# Planning Referral

**To:** Michelle King  
**From:** Chloe Wright  
**Date:** 19/05/2020  
**Subject:** Strategic Transport Comments  
**Application No:** PLN20/0006  
**Description:** Construction of a thirteen-storey building (including one level of plant, plus two basement levels), reduction in the car parking requirement associated with the retail/food and drinks premises and office uses (no permit required for uses) and alteration of access to a Road Zone, Category 1.  
**Site Address** 462 – 482 Swan Street, Richmond

Figure 1 – four existing hoops at the corner of Burnley and Swan Street should be relocated.

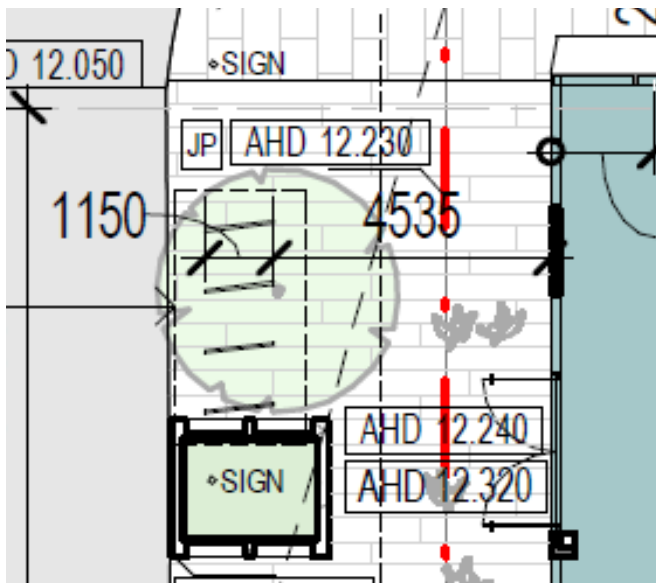
- The Traffic report notes 64 visitor bicycle spaces are proposed at the street level, however the plans show 56 proposed visitor bicycle spaces and 4 existing bicycle hoops (providing 8 existing spaces) at the corner of Burnley and Swan Street.

- The 4 existing hoops at the corner of Burnley and Swan Street (shown in Figure 1 below) should be relocated to an alternative location, given the proposed tree and raised garden bed / seating within this area.

- Council's best-practice rate<sup>1</sup> generates a recommendation of 66 visitor spaces for the development. Given the 4 existing hoops are immediately outside the site, it is acceptable to include these hoops as part of the total provision of visitor spaces, if they are relocated to a suitable location.
